# 1957 - 1958 Corvette: Service News: Corvette 4-Speed Transmission - Harsh Shift Into Third Speed

**Source:** Chevrolet Service News

**Date:** December, 1957

**Subject:** Corvette 4-Speed Transmission - Harsh Shift Into Third Speed

*Fig. 3--Checking Third Speed Gear*

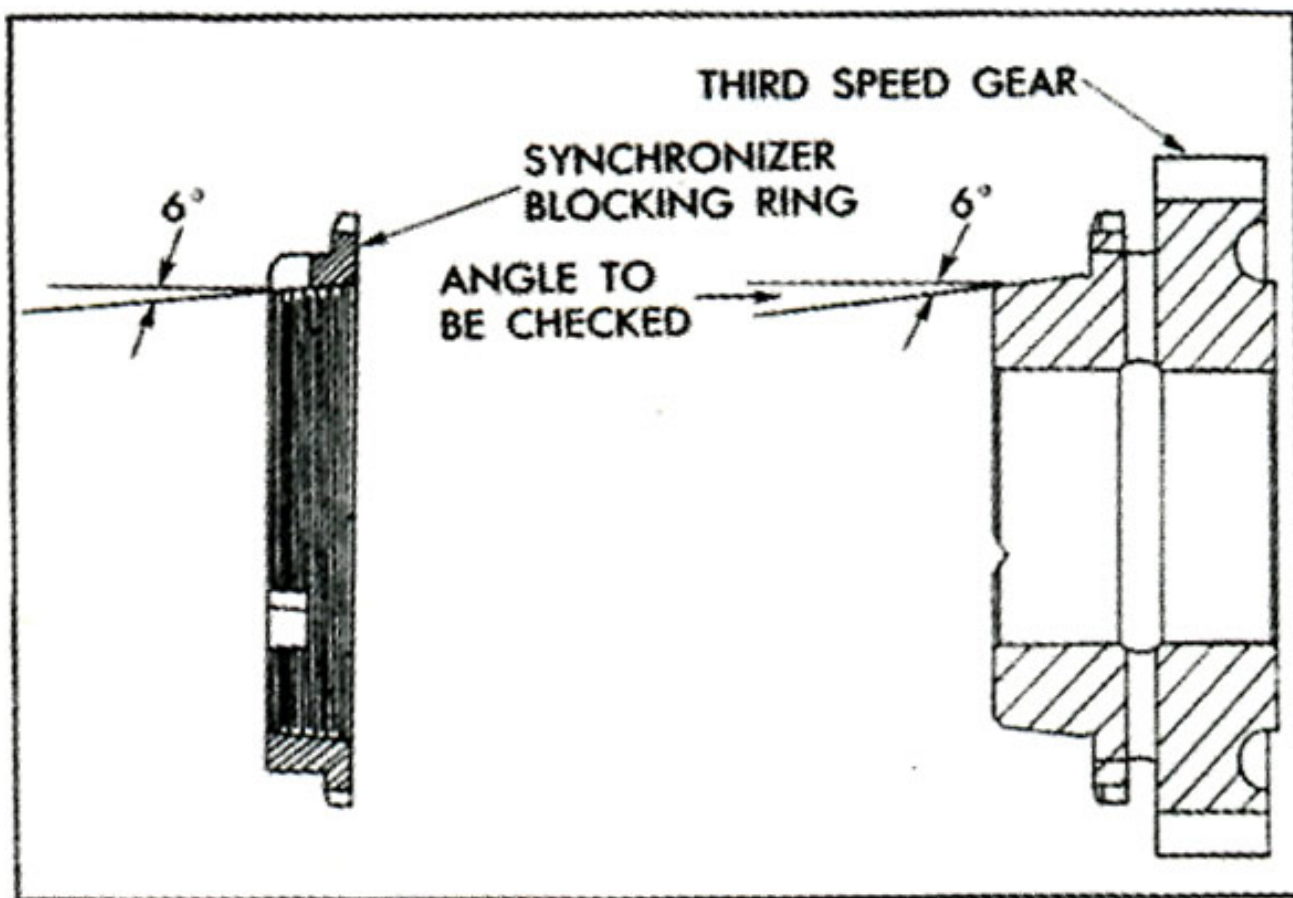
Some 1957 and 1958 Corvette four-speed transmissions have been built incorporating a third speed gear with  $7^\circ$  cone angle rather than the specified  $6^\circ$ , as illustrated in Figure 3. This may cause a harsh shift into third speed due to the resultant improper engagement of the synchronizer blocking ring and third speed gear cone.

1. Coat I.D. of blocking ring lightly with a dye such as Prussian Blue.
2. Carefully install the blocking ring on the third gear cone to obtain an engagement impression.
3. If the Prussian Blue impression on the cone is all at the rear (or predominantly at the rear) the cone angle can be assumed to be  $7^{\circ}$  and should not be used. If the Prussian Blue is more or less evenly distributed on the cone surface, the angle is correct.

The suggested correction, if the harsh shift is encountered, is to replace the third speed gear assembly No. 3743452 and the synchronizer blocking ring No. 3709348.
